ADDENDUM NO. 2
INDIAN CREEK WRF EXPANSION TO 3 MGD
HENRY COUNTY WATER AUTHORITY

This addendum hereby amends and/or modifies the Contract Documents, Detailed Specifications, and Drawings, as indicated, that have been issued for this project by Engineering Strategies, Inc. Additionally, questions received by the Engineer are answered at the end of this addendum. All bidders are subject to the provisions of this addendum and shall acknowledge receipt of this addendum on the bid form.

BUILDING SCHEDULES AND DETAILS

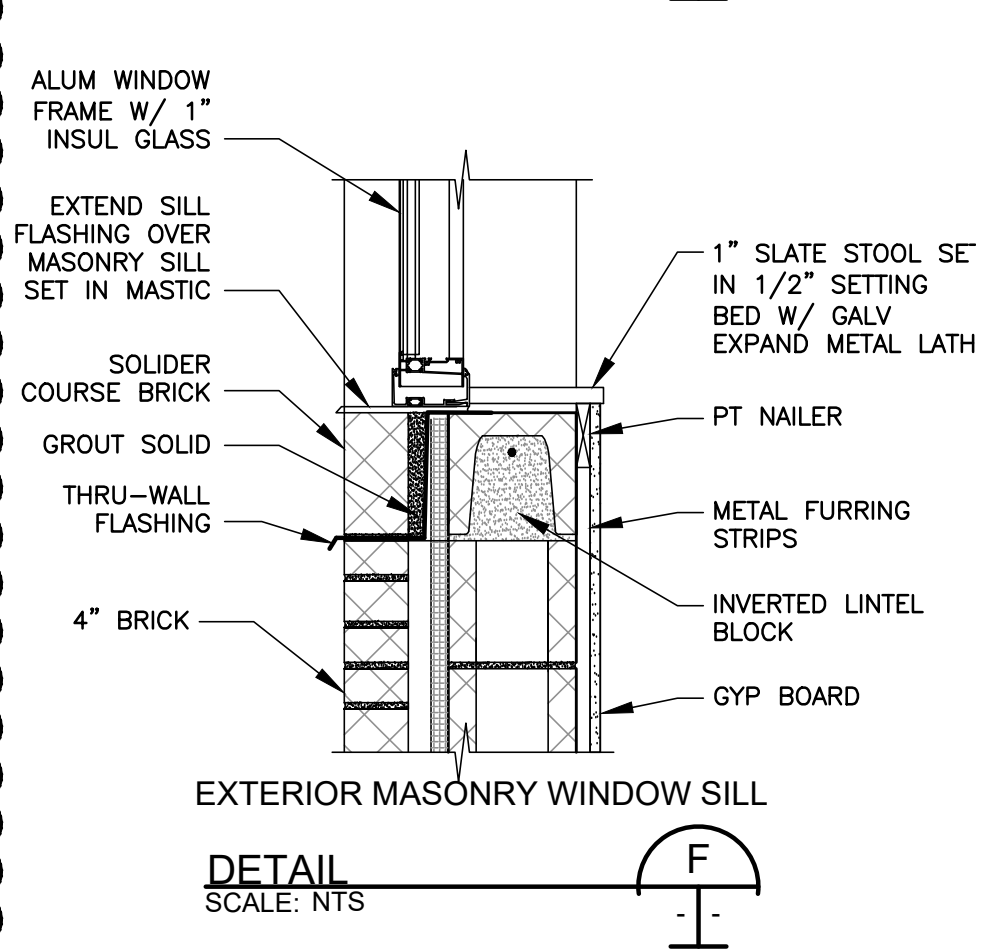
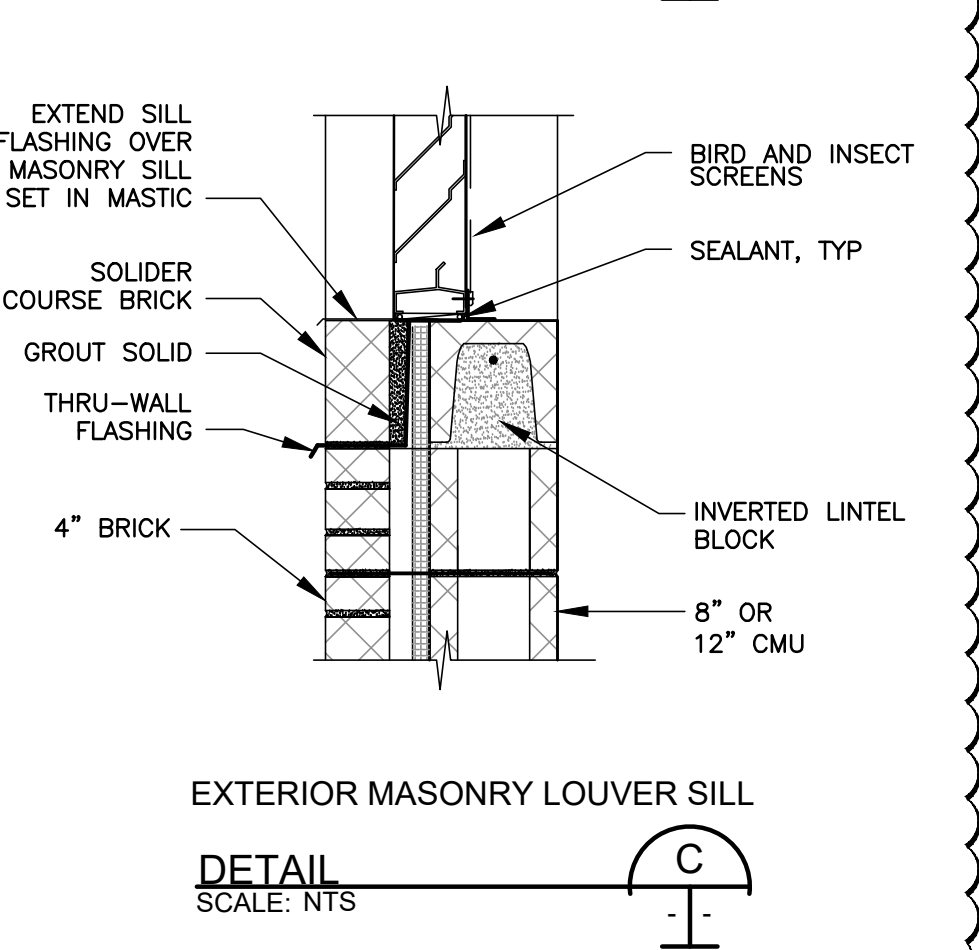
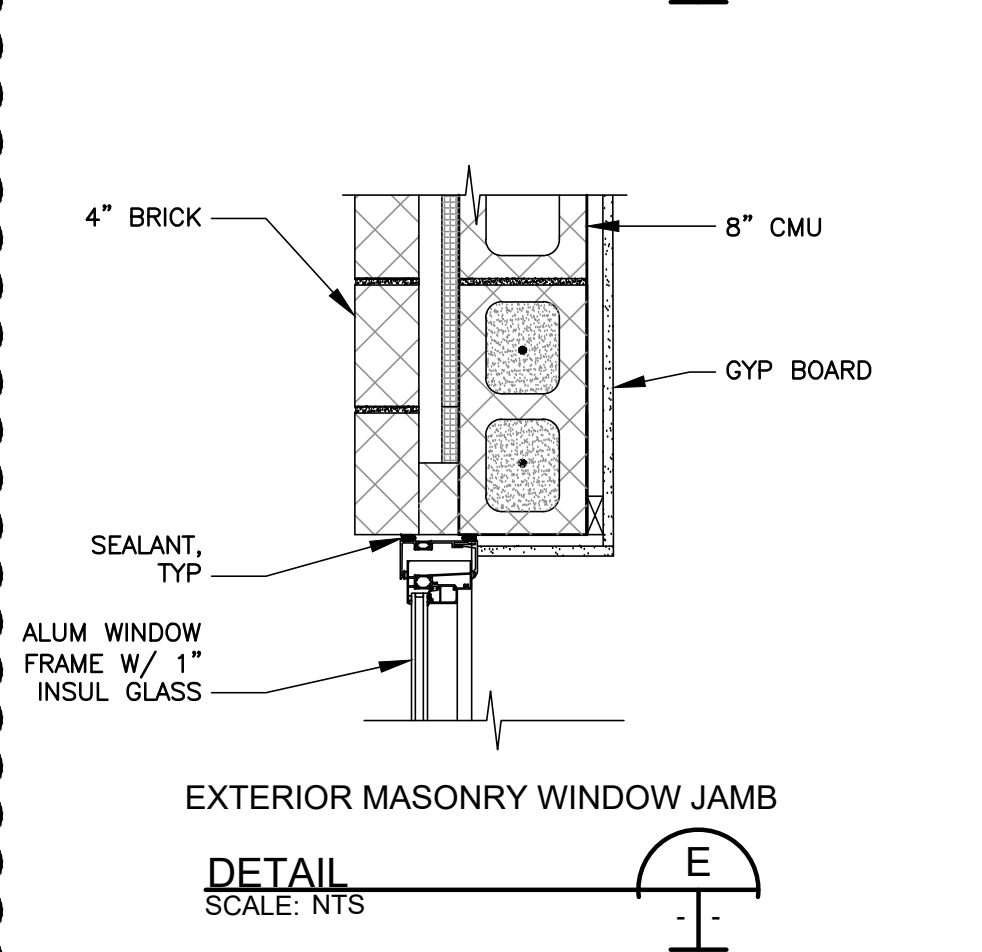
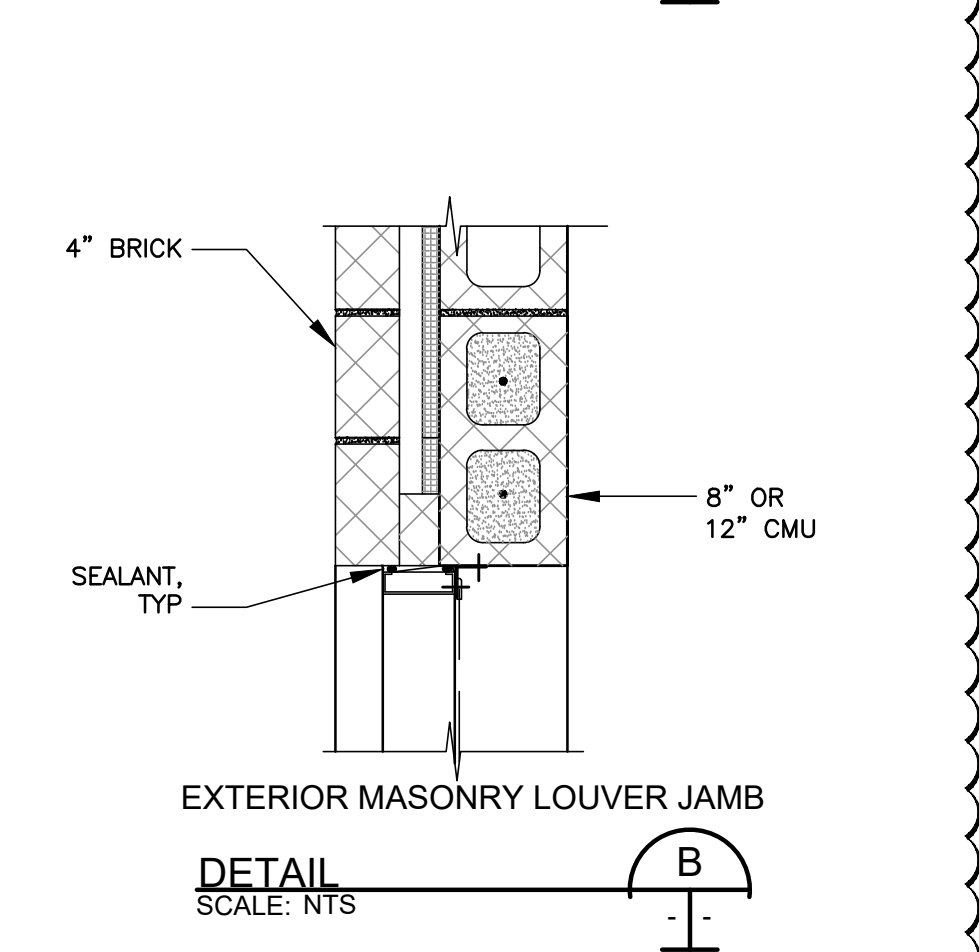
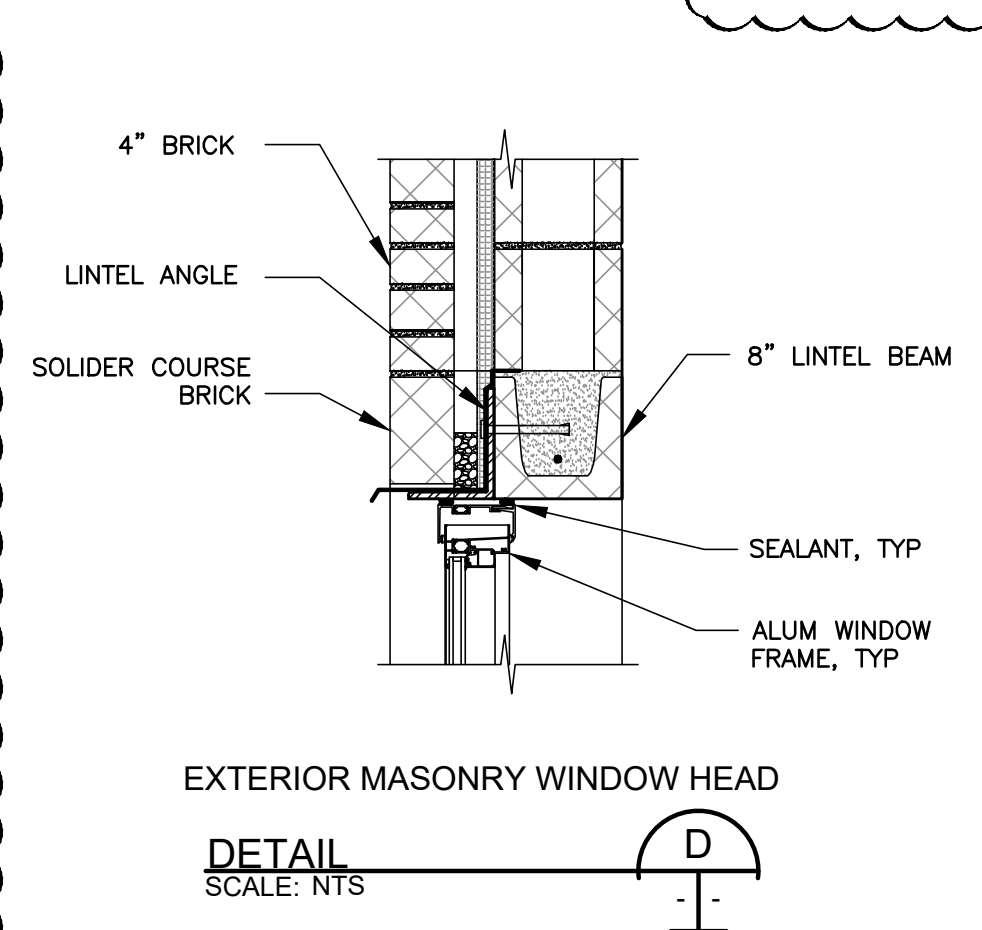
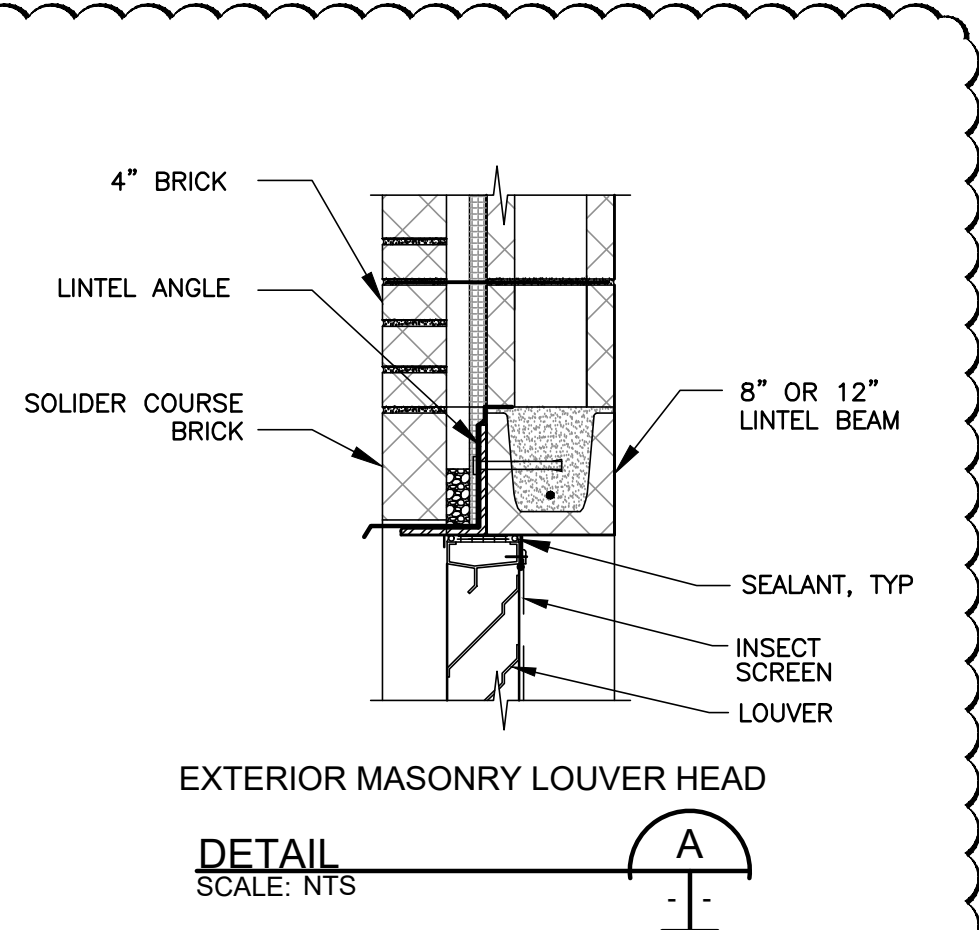
- Q2-8: *The Room Finish Schedule finish schedule shows epoxy flooring to be installed in rooms 103, 104, and 105. Can you confirm that these rooms will receive the epoxy flooring and if so, can you provide specifications and/or detail?*

- A2-8: Room 103 (MBR Process Electrical Room) does not need to be painted. Room 104 (MBR Process Sodium Hypochlorite Feed Room) and Room 105 (MBR Process Citric Acid Feed Room) shall be painted using Coating System No. 27.
